Didsbury Point

Non Material Amendments

Project name: Didsbury Point
Project number: 8845
Client: Southway Devco

Following recent approval of the Section 73. submission this document aims to pick up all remaining non material amendments made to the consented residential development; Didsbury Point (planning application ref. 135235/FO/2022), during the design development stage.

East Elevation

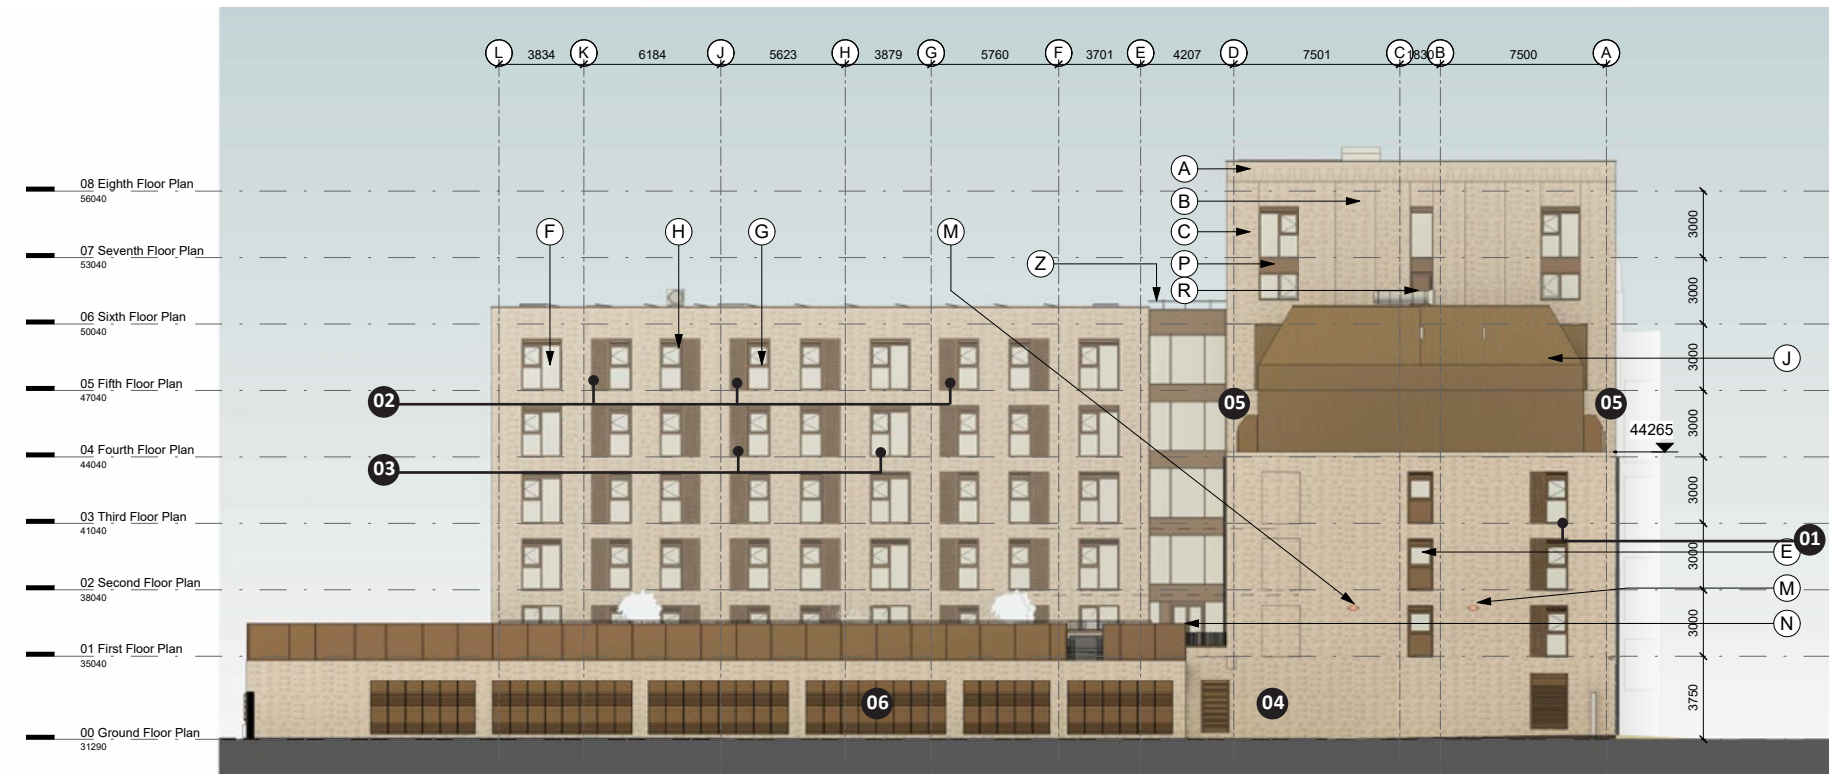
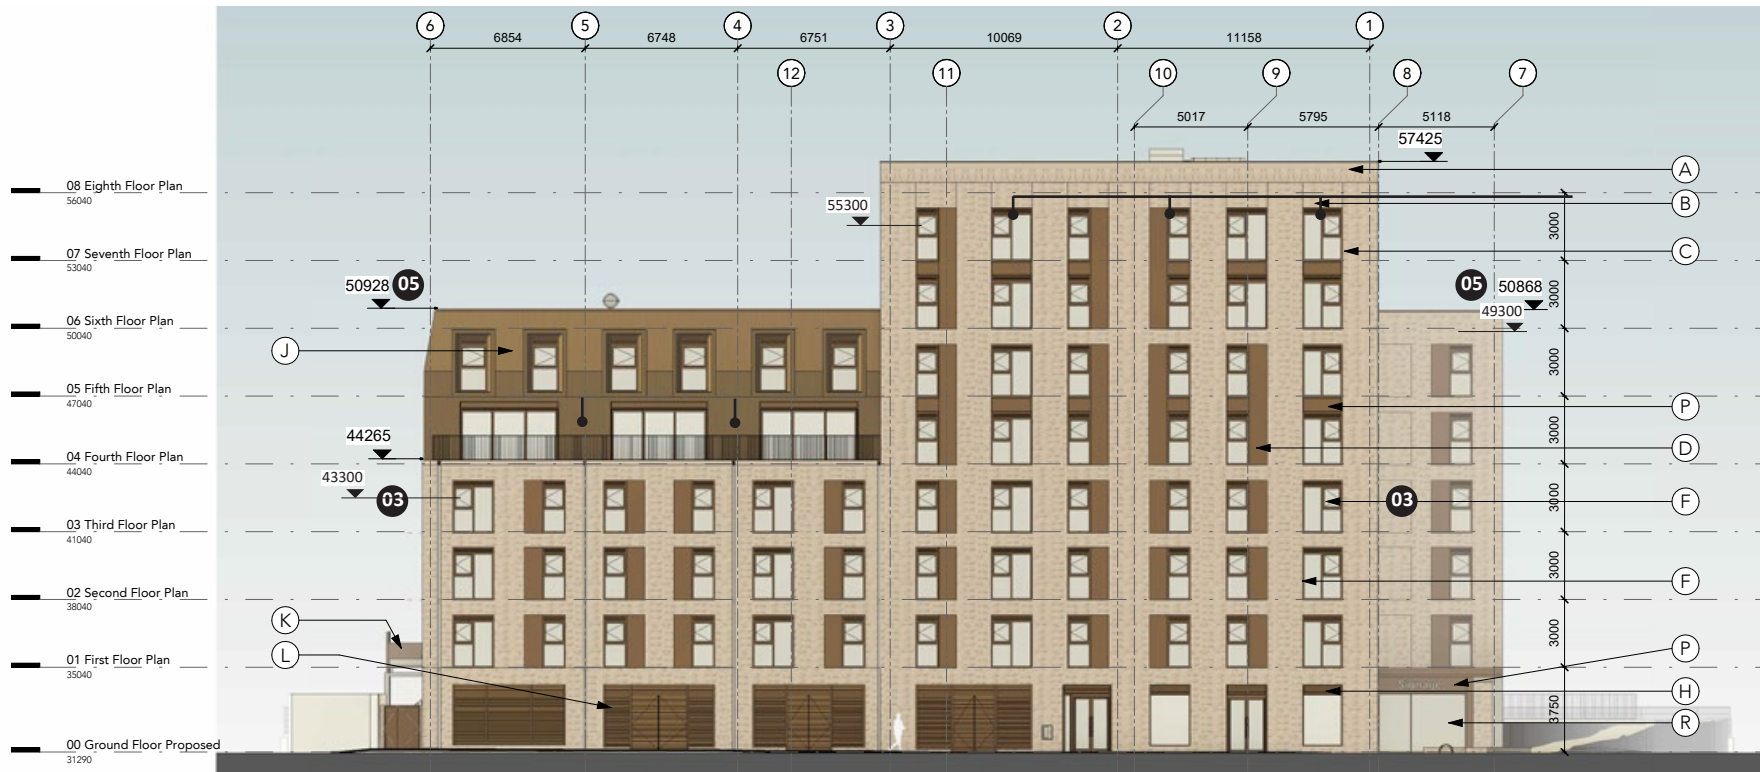
01. Window height reduced

02. Car park podium materiality changed to alternating louvred screens and brick piers

03. All window structural opening heights increased by 75mm and transom proportions altered to achieve height of 1100mm from FFL

04. Car park green wall removed

05. Lower block heights increased by 225, 268 or 995mm

06. Position of ramp to car park altered.

07. Changes to louvred screens to ground floor

01. Windows in column to have obscure glazing

02. Windows (& perforated panel) in column mirrored

03. Perforated spandrel panel added / removed from window column. See 'Proposed Bay Study Sh. 1' for details

04. Bin store relocated so door removed

05. Privacy screens added between and at end of duplexes at terrace level (x6 in total)

06. Mullion design updated to car park louvres

North Elevation

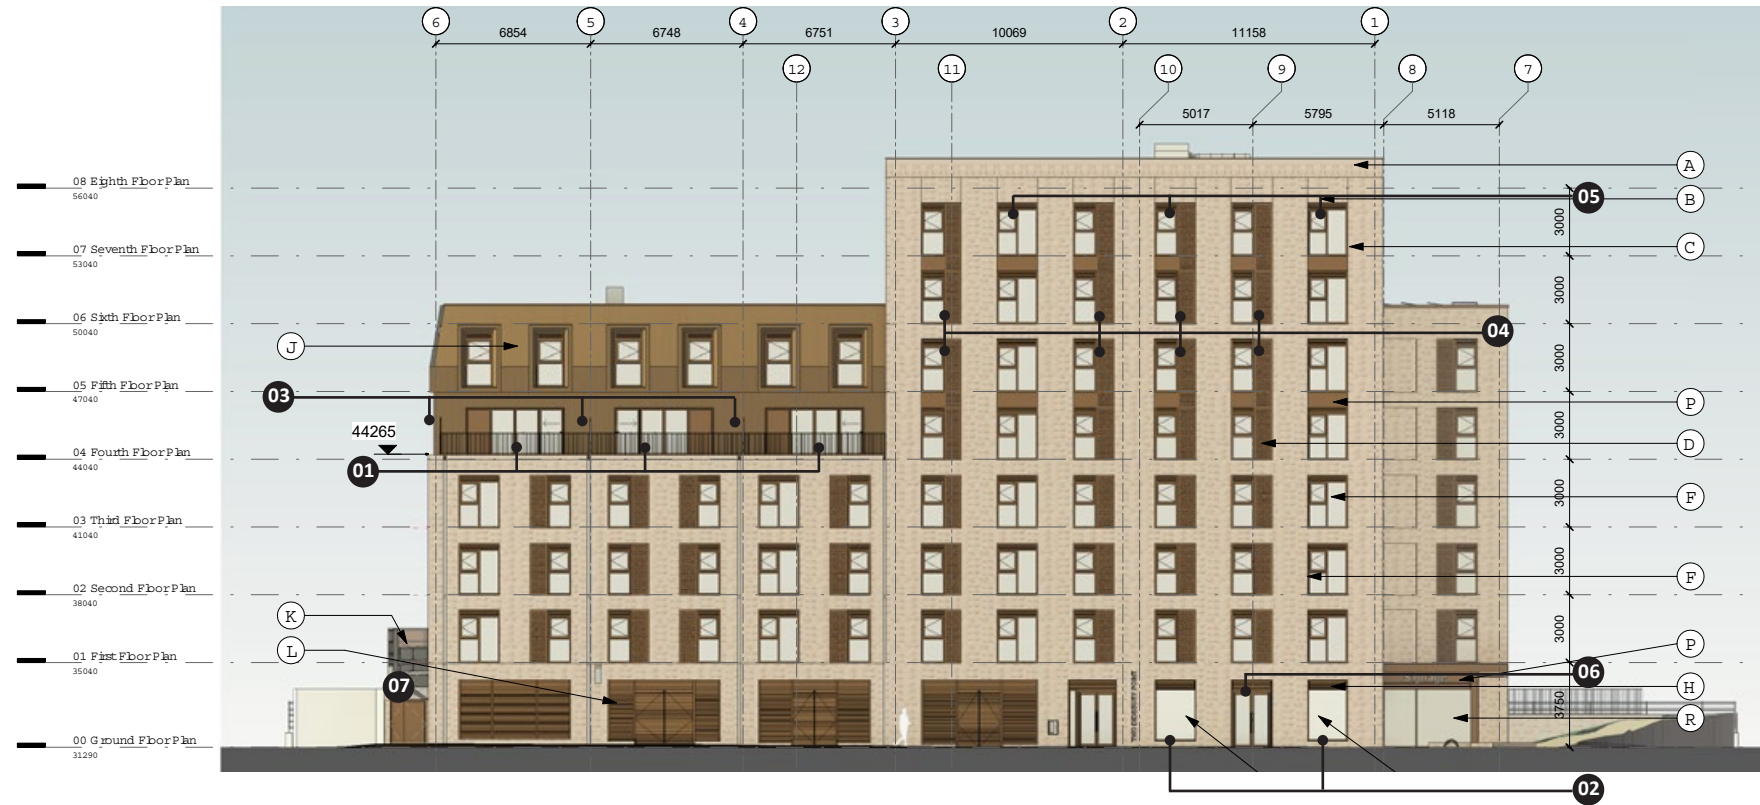
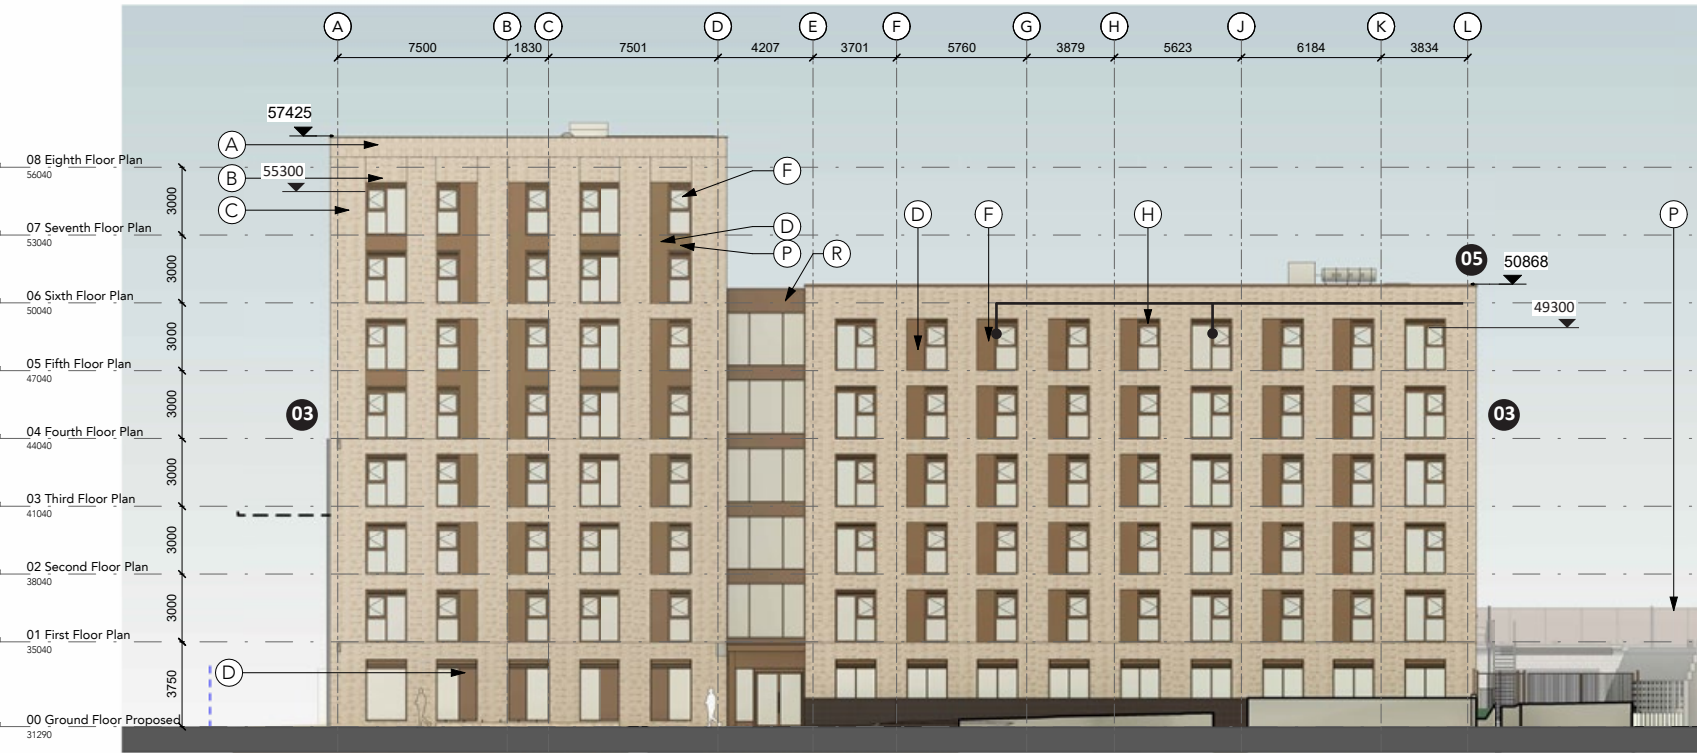
03. All window structural opening heights increased by 75mm and transom proportions altered to achieve height of 1100mm from FFL

05. Lower block heights increased by 225, 268 or 995mm

07. Changes to louvred screens to ground floor

01. Glazed screens updated to '4 panel' arrangement with integrated patio door

02. Areas of obscure glazing to medical centre

03. Privacy screens added between and at end of duplexes at terrace level (x6 in total)

04. Joints to double height windows with perforated panel added. See 'Proposed Bay Study Sh. 2' for details

05. Windows (& perforated panel) in column mirrored

06. Medical centre entrance / exit altered

07. Gate to east boundary moved towards northern elevation building edge

West Elevation

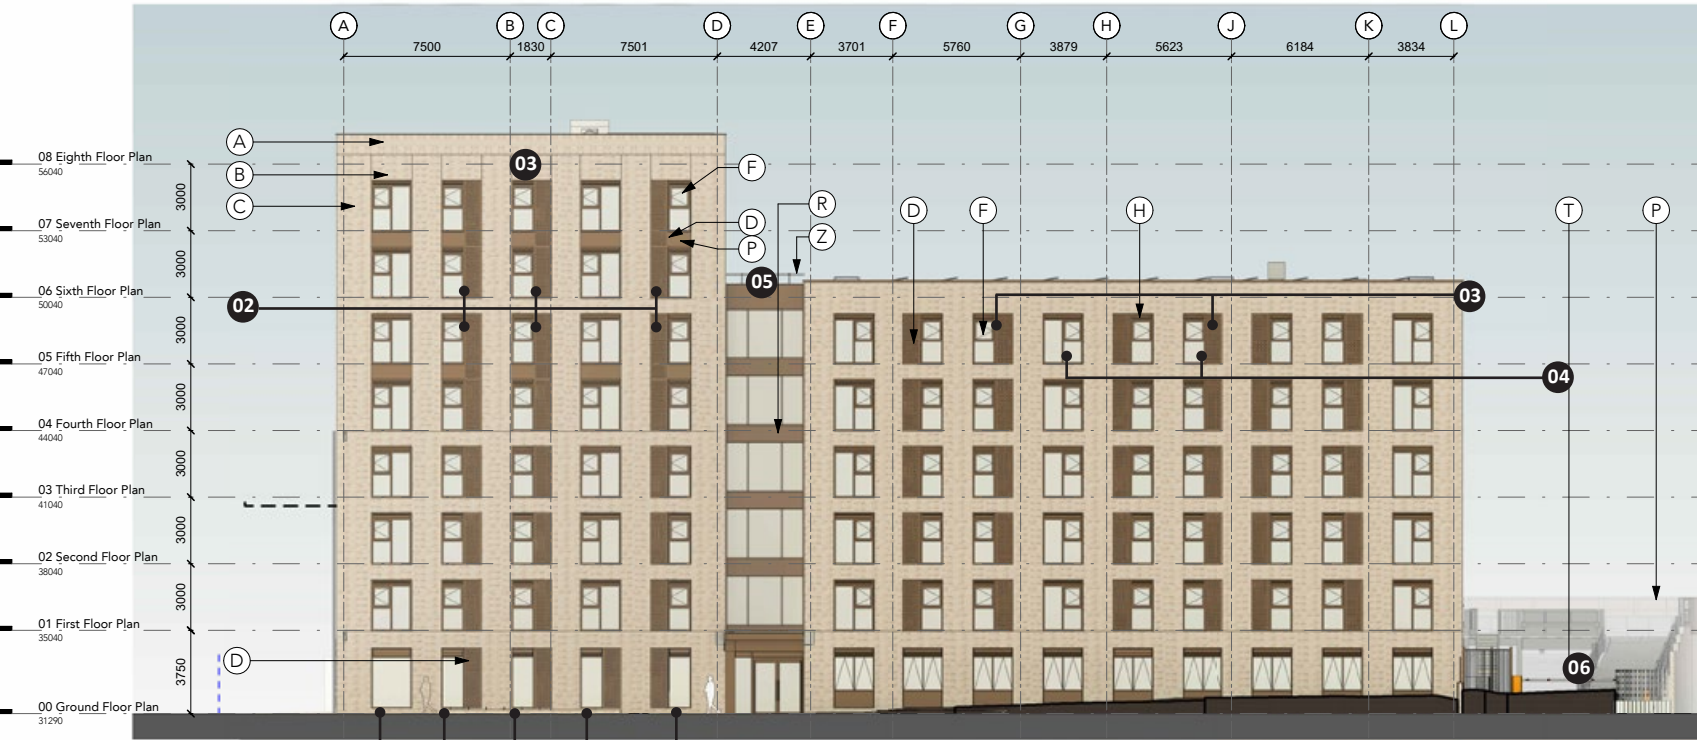
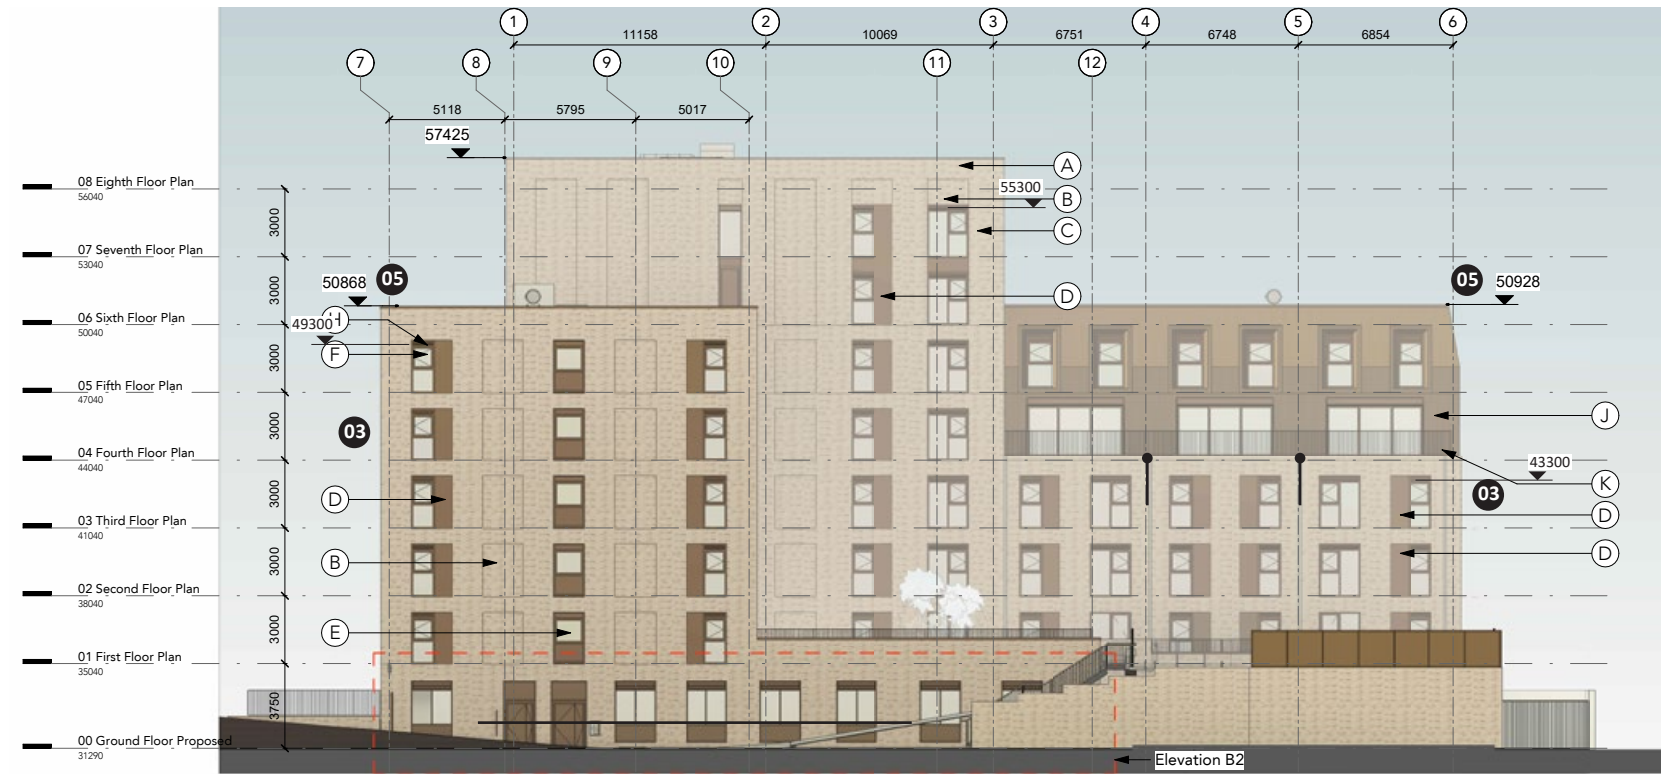
03. All window structural opening heights increased by 75mm and transom proportions altered to achieve height of 1100mm from FFL

05. Lower block heights increased by 225, 268 or 995mm

01. Areas of obscure glazing to medical centre
02. Joints to double height windows with perforated panel added. See 'Proposed Bay Study Sh. 2' for details
03. Windows (& perforated panel) in column mirrored
04. Perforated spandrel panel added / removed from window column. See 'Proposed Bay Study Sh. 1' for details
05. Increased spandrel height to full height curtain wall
06. Security Parking Barrier added (appearance TBC)
